Department of Energy
Washington, D.C. 20545

Docket No. 50-537
HQ:S:82:044

RESPONSES TO REQUEST FOR ADDITIONAL INFORMATION - STRUCTURAL ENGINEERING

Reference: Letter, P. S. Check to J. R. Longenecker, "CRBRP Request for Additional Information," dated February 26, 1982

Figure 3.5-1. Comparison of Missile Penetration Formulas for Concrete

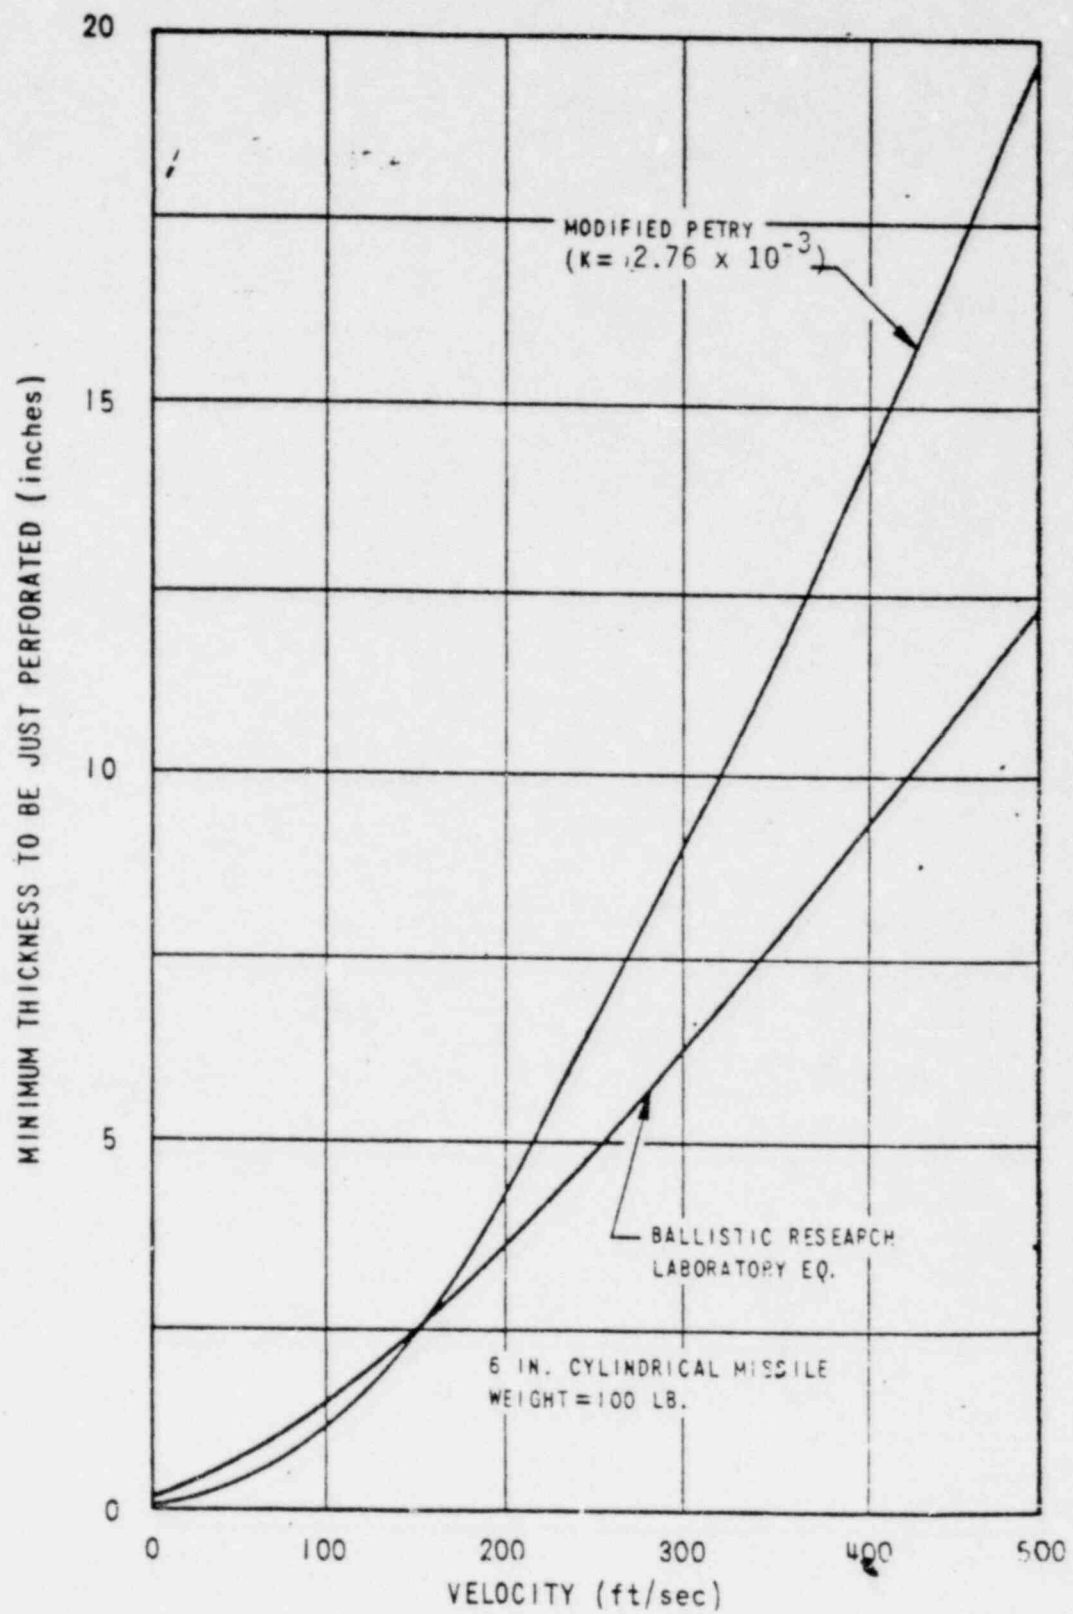
The revised Petry equation for penetration depth as a function of velocity seems to have been copied incorrectly in that the term in the exponential is dimensionally incorrect and the term V' , which is a logarithm, is given with a dimension (the velocity dimension should be incorporated in K). Further the K in the text does not agree with the K in Figure 3.5-1. It is requested that corrections be made. Indicate how you calculate d_m for a noncylindrical or nonspherical projectile?

PSAR Section 3.5.4.1 will be revised to show that the term V' does not have the dimension ft/sec and that the term a should be equated to $T_p/KApV'$. The value of K in PSAR Figure 3.5-1 will be corrected to 2.76×10^{-5} to agree with PSAR Section 3.5.4.1.

CRBRP BUILDING MATHEMATICAL MODEL
FOR THE E-W EARTHQUAKE

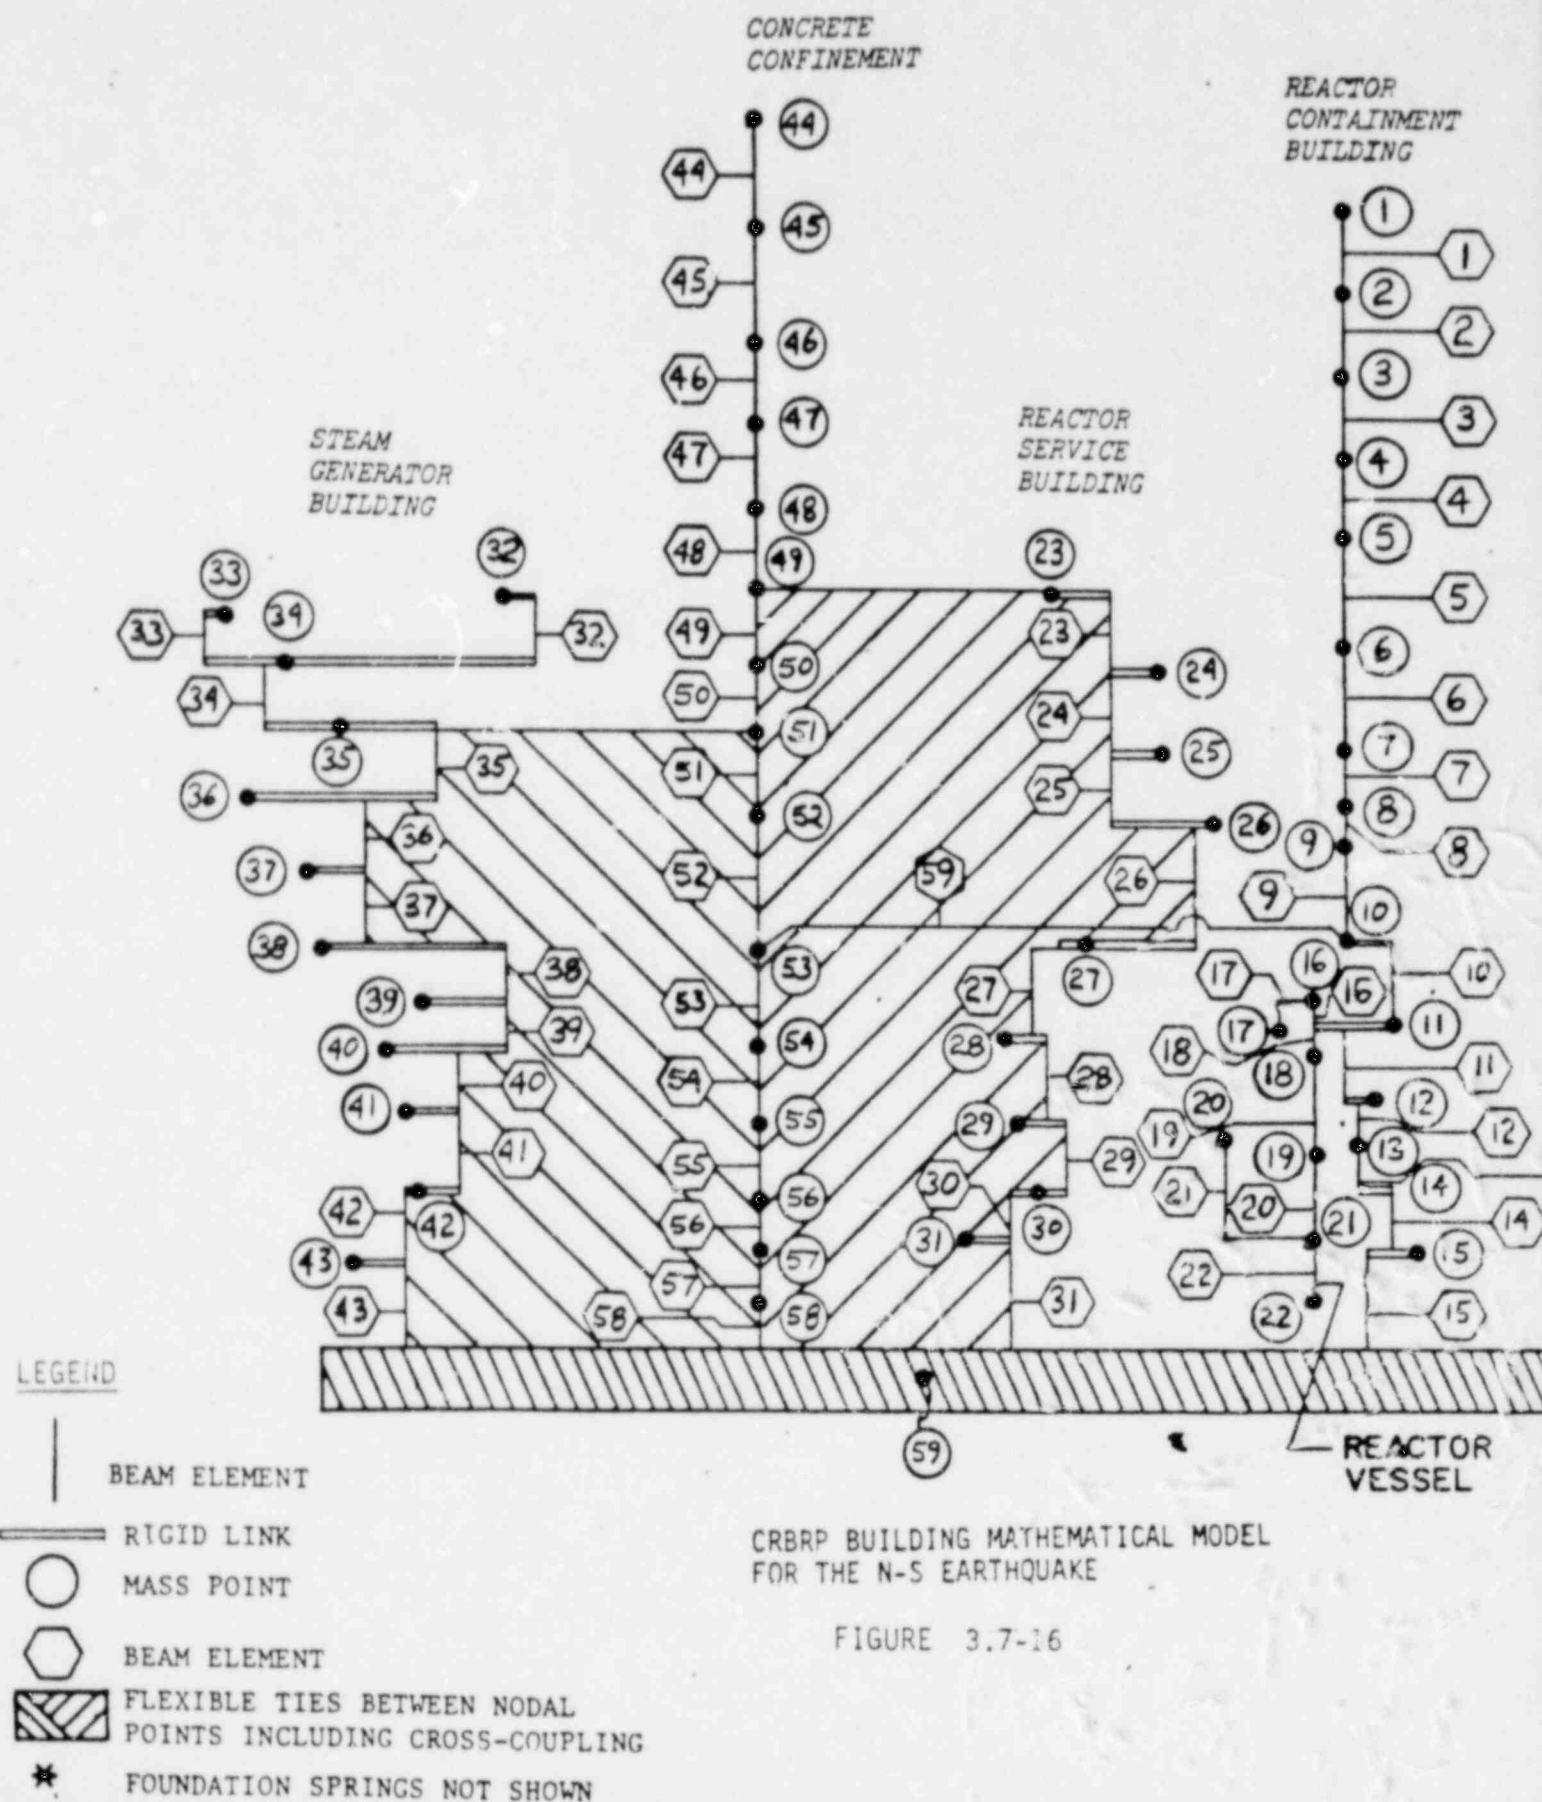
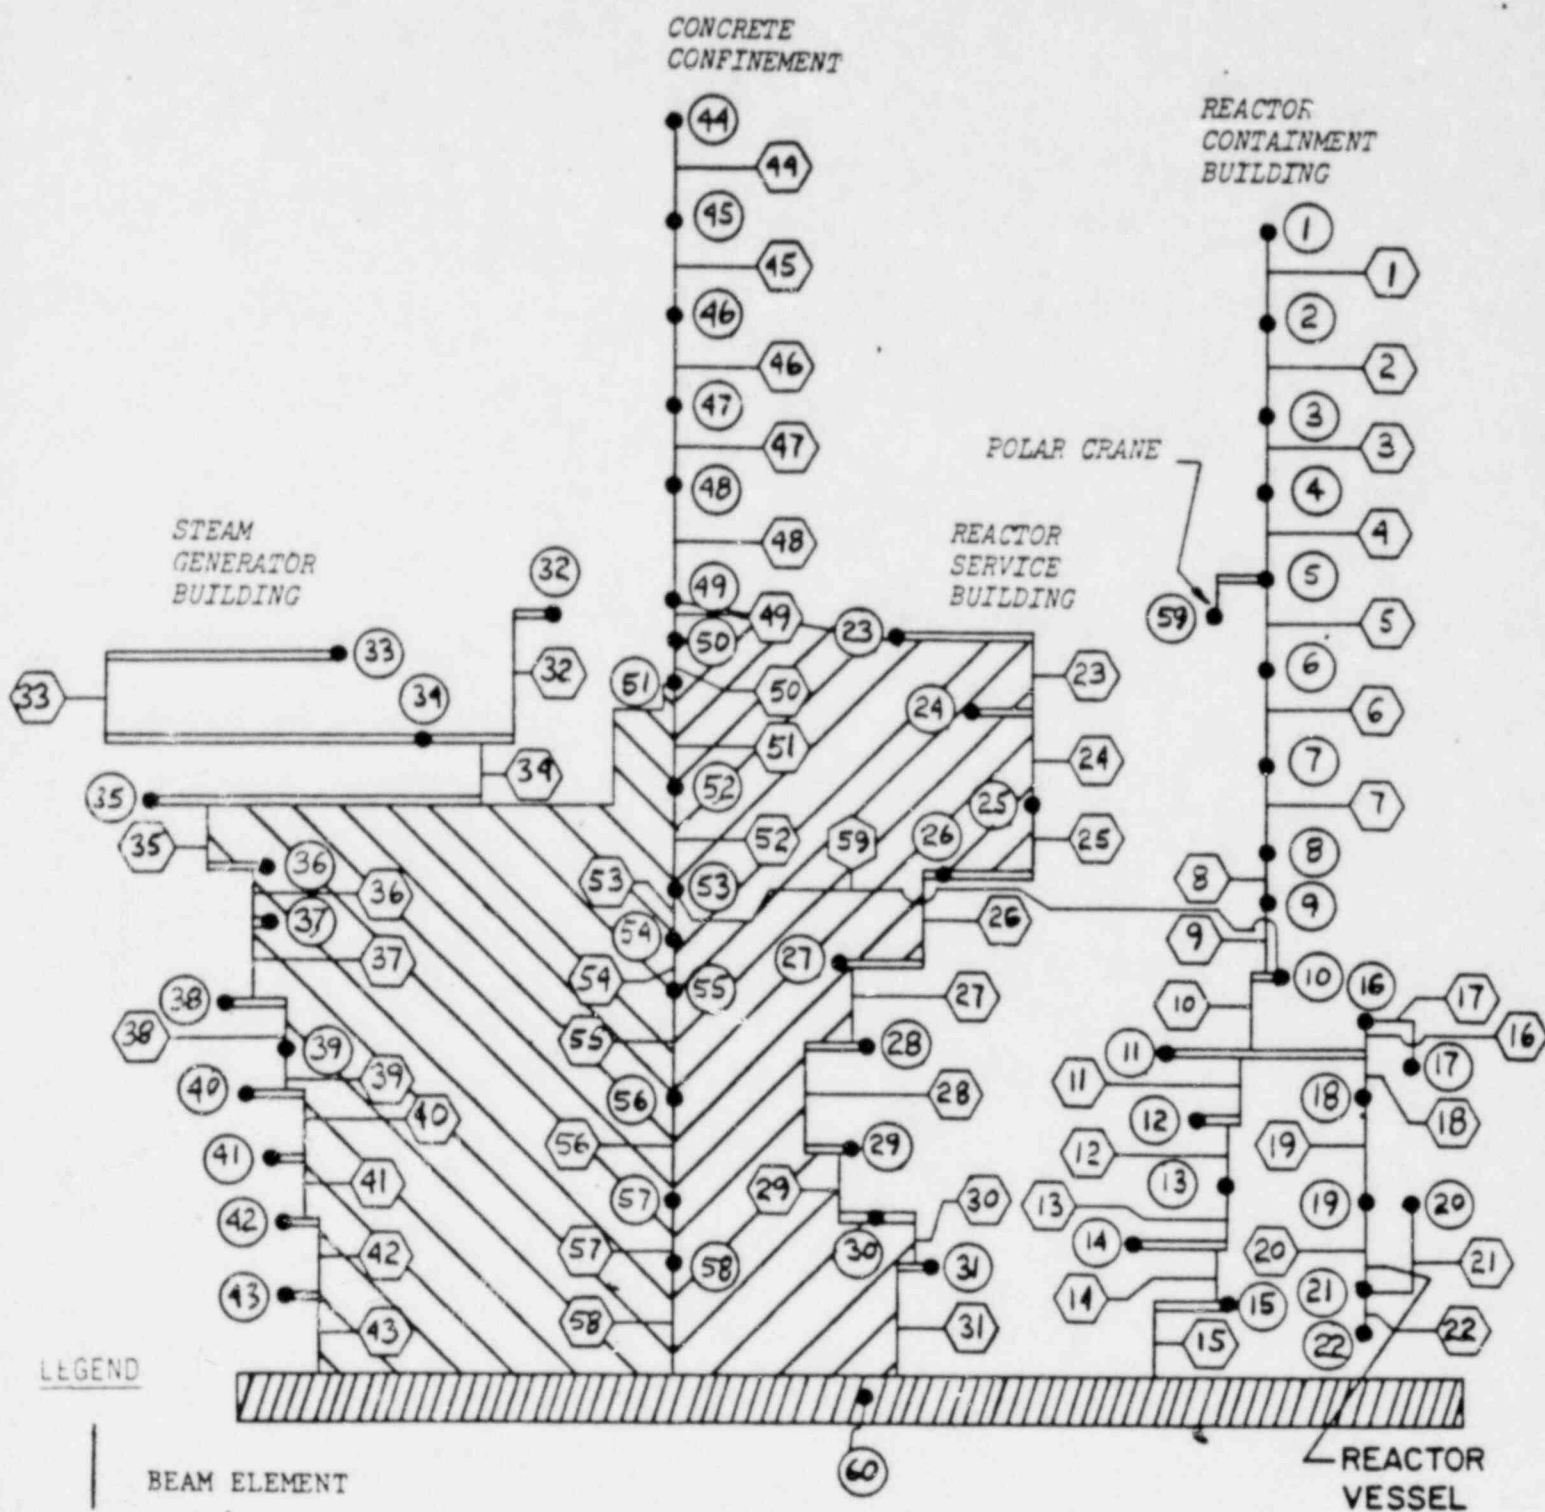
It is stated that for a lumped-mass-spring type of models the seismic design response spectra will be applied at the foundation. The mathematical models as shown in Figures 3.7-16, 3.7-16A, and 3.7-16B are the lumped-mass-spring type. Indicate how the springs and dashpots representing soil are derived from a static finite element model. Provide a description in detail.

Further, the mathematical models in Figures 3.7-16, 3.7-16A, and 3.7-16B lack numerical details. No one could judge the adequacy of plans for a plant model based on the material given on these diagrams. A full discussion with tables should be provided delineating the numbers, their meanings, etc.

The attached diagrams are the updated mathematical models used in the seismic analysis of the Nuclear Island buildings. Figures 3.7-16, 3.7-16a - and 3.7-16b show respectively the mathematical models for the analyses in the North-South, East-West and Vertical directions.
